35/13-04Z 25 Oxford Street
Chevy Chase Historic District

Re: Alterations to approved HAWP application at 25 Oxford Street, Chevy Chase
Village Historic District

SUBJECT: Historic Area Work Permit – Additions and Alterations to a non-contributing resource at 25 Oxford Street, **Chevy Chase Village Historic District**

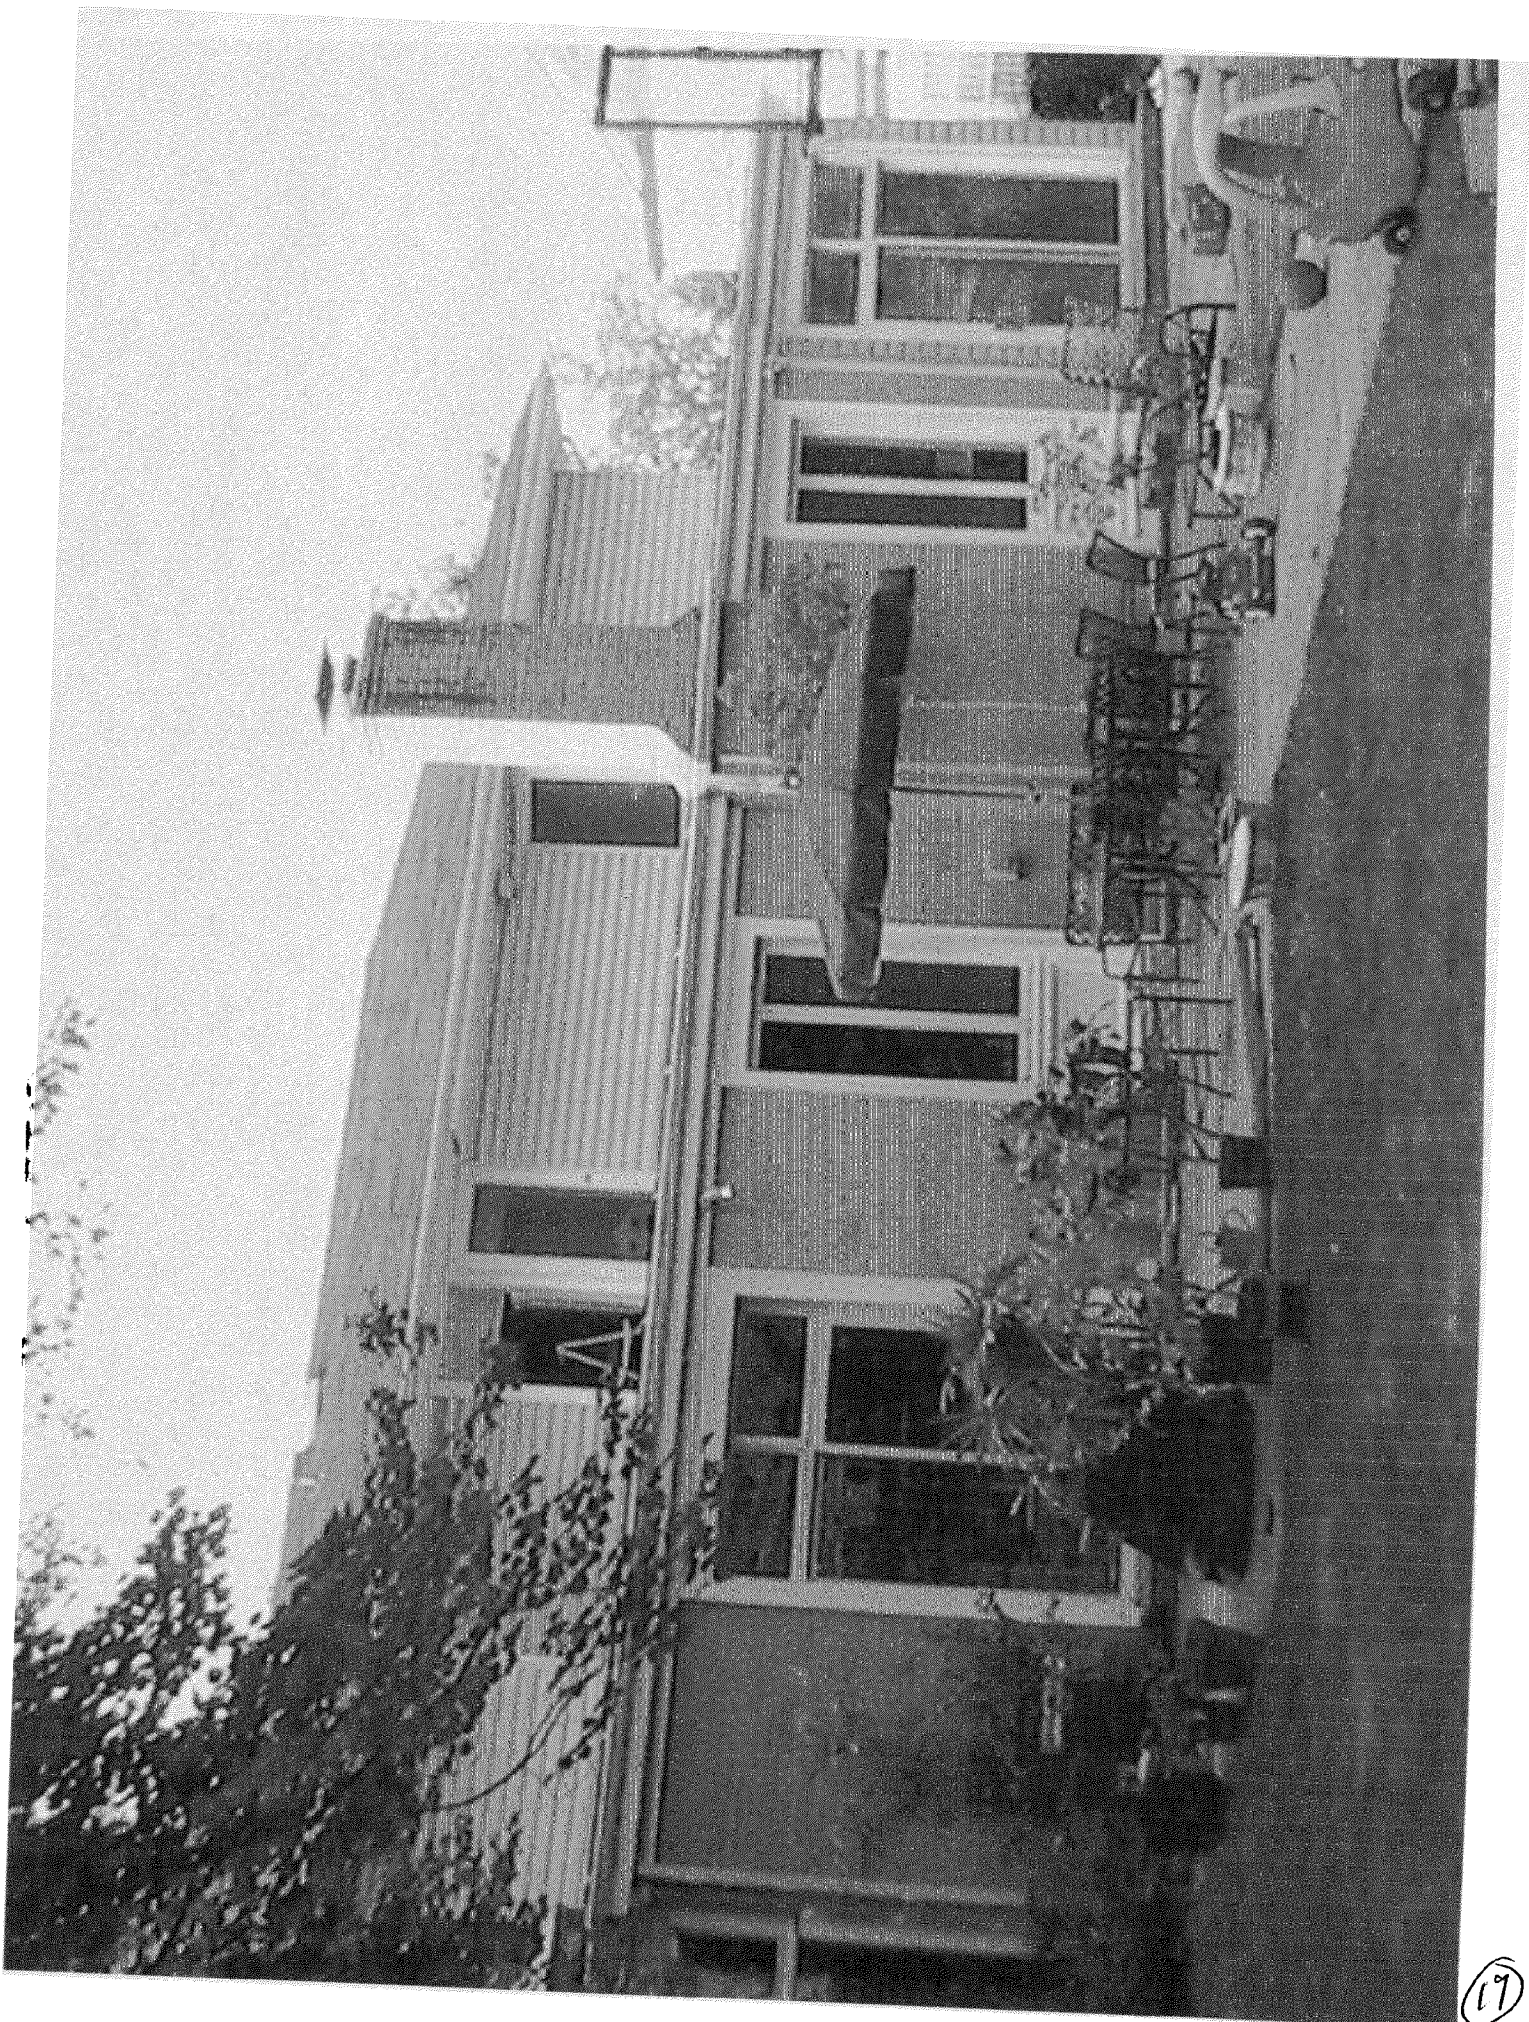
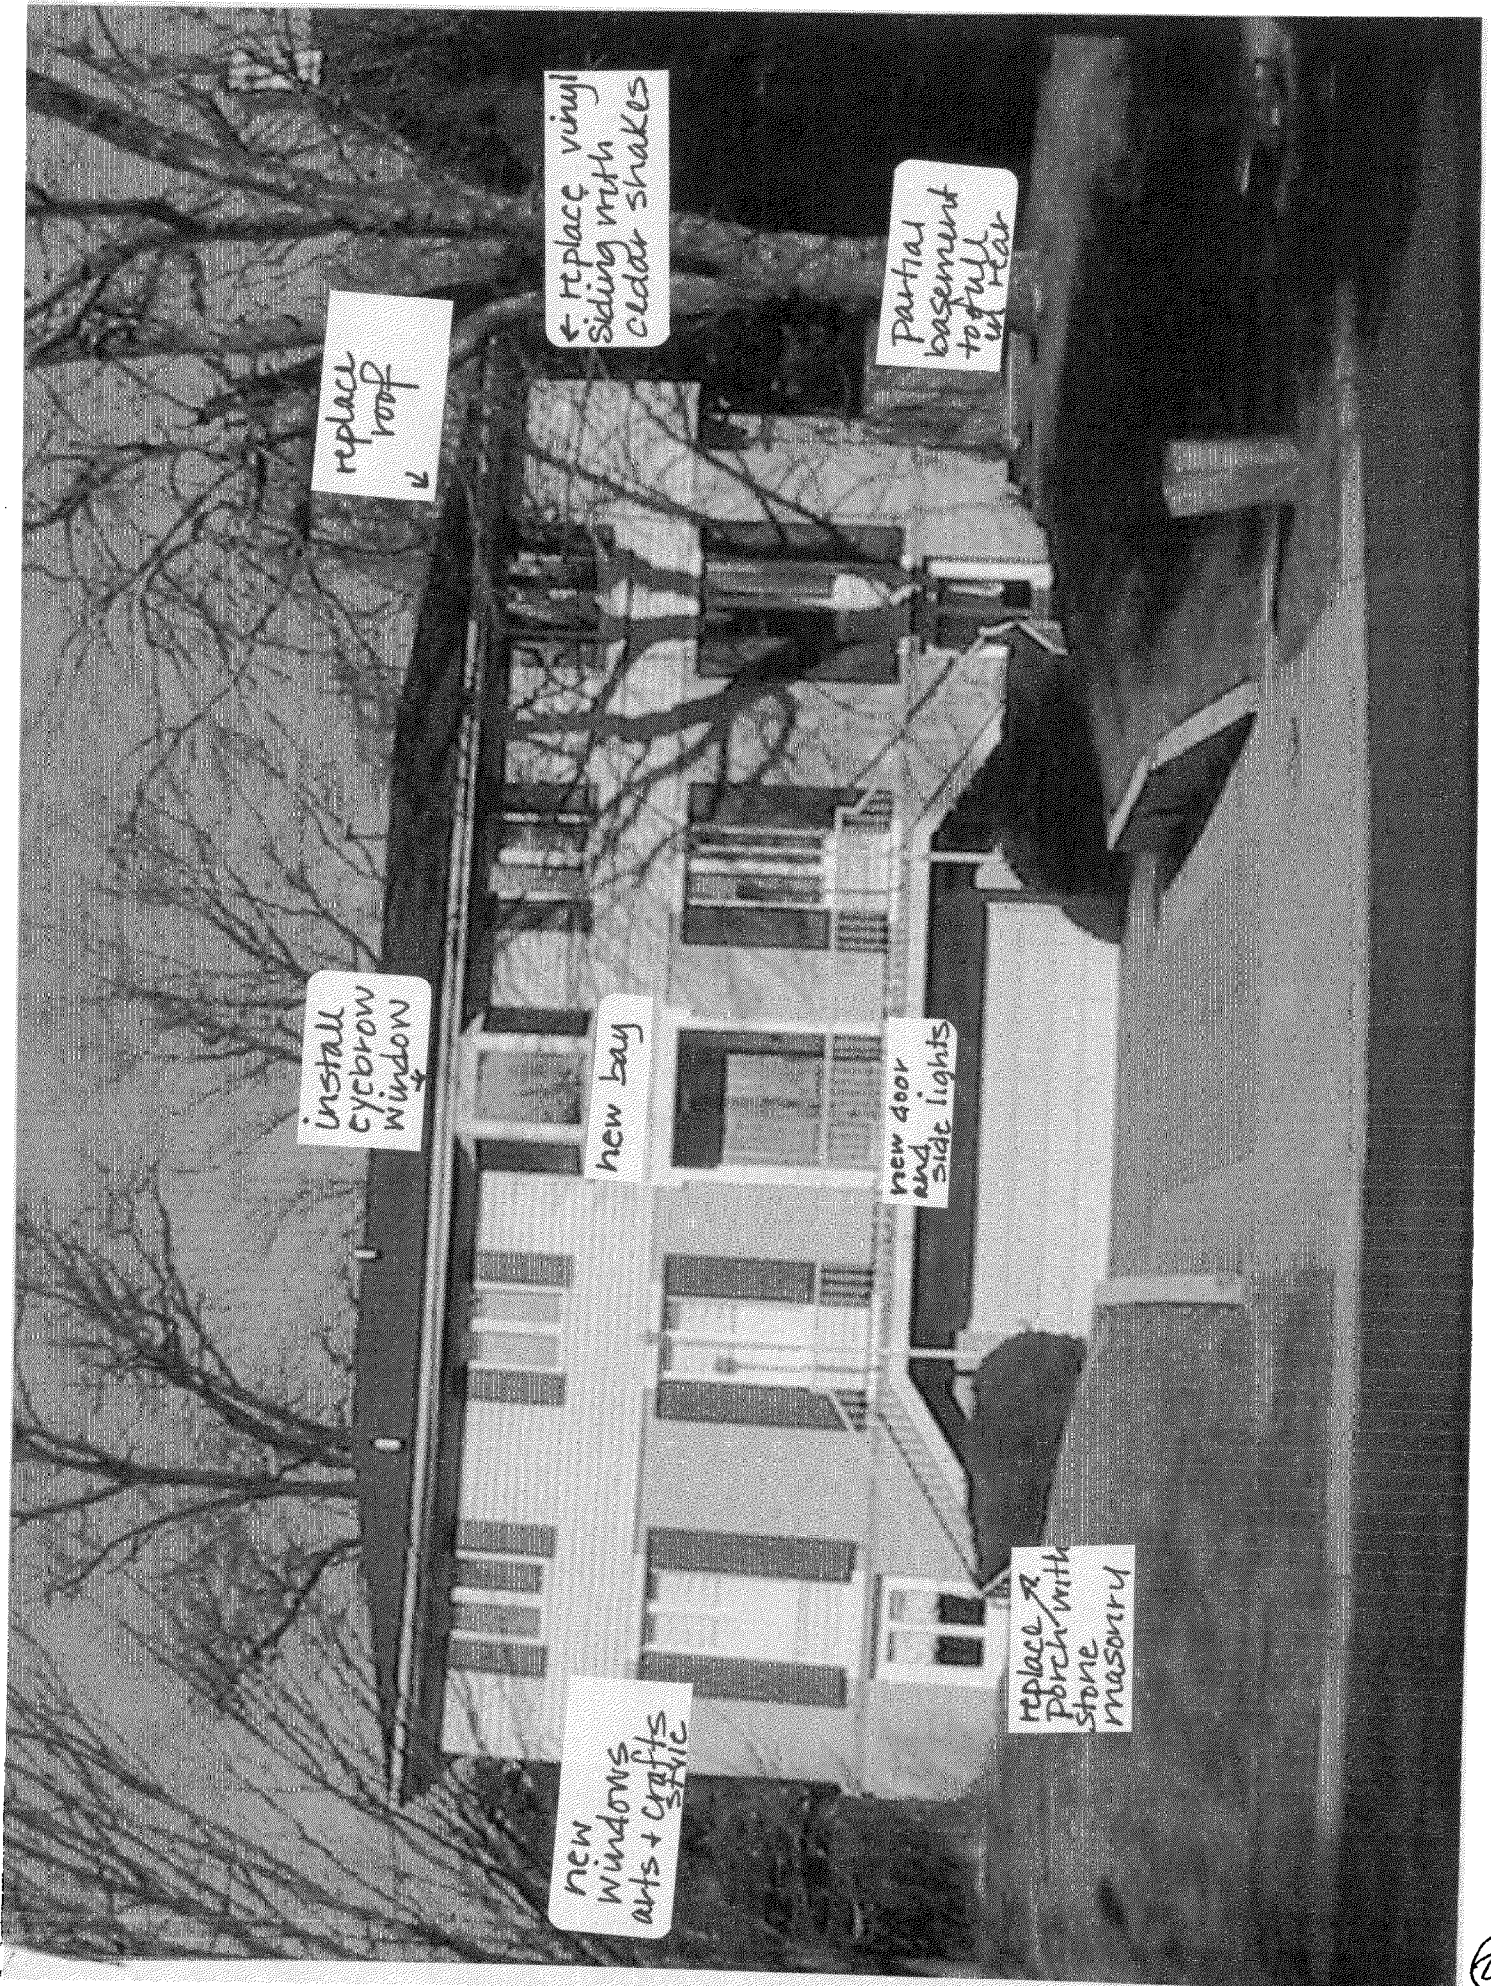
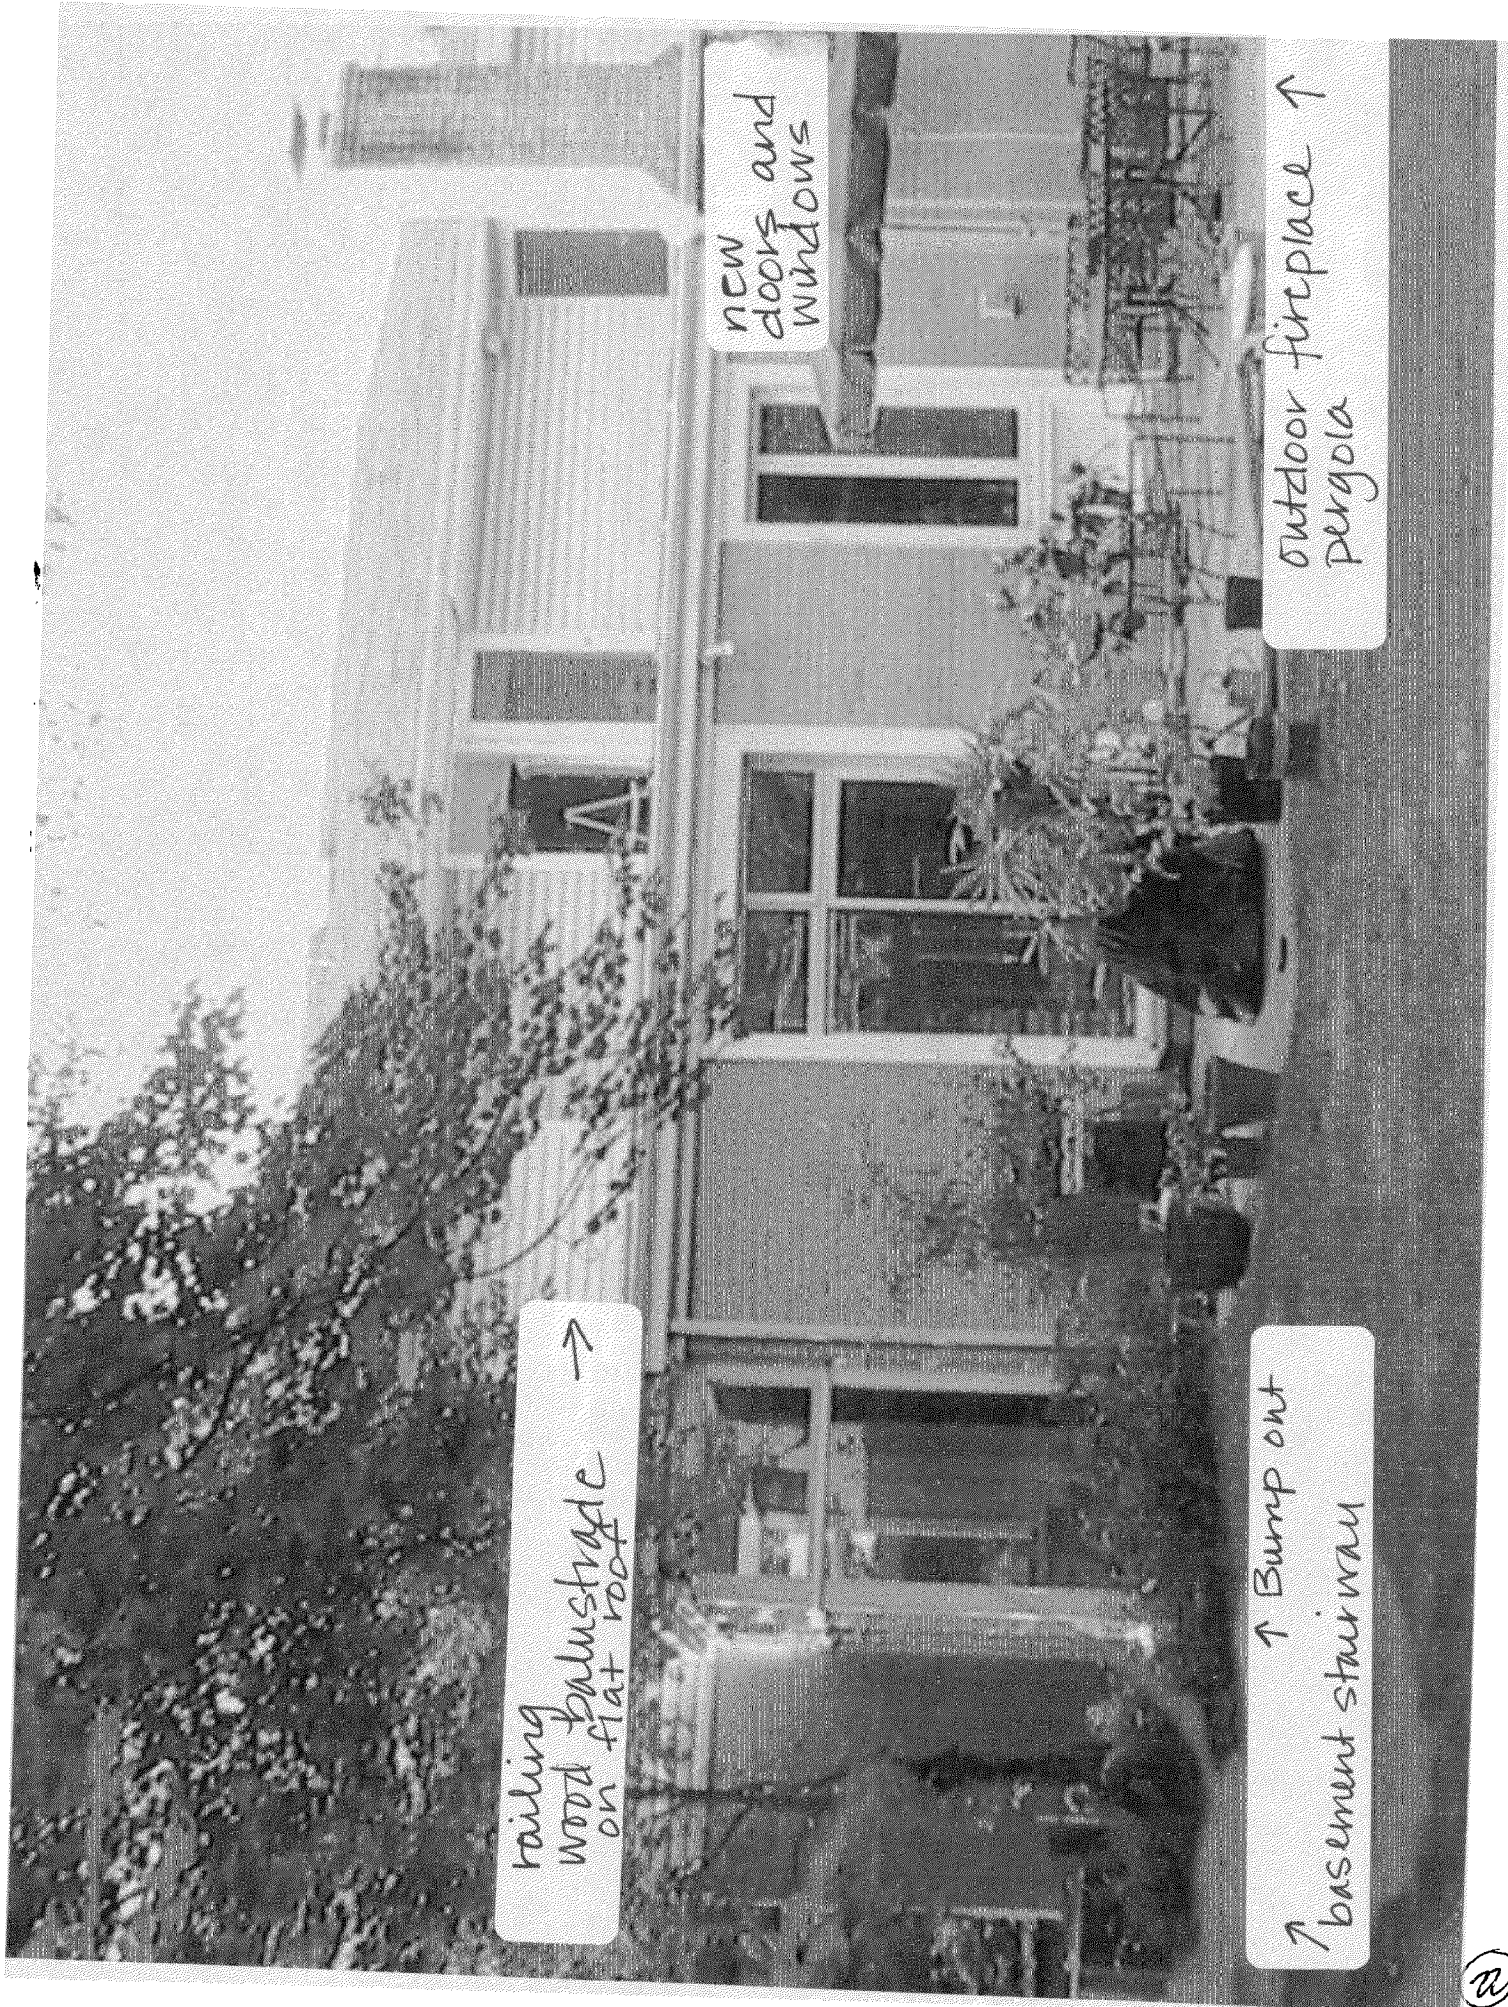
replace roof

← replace vinyl siding with cedar shakes

new door and side lights

replace porch with stone masonry

new windows arts + crafts style

railing balustrade
wood on flat roof →
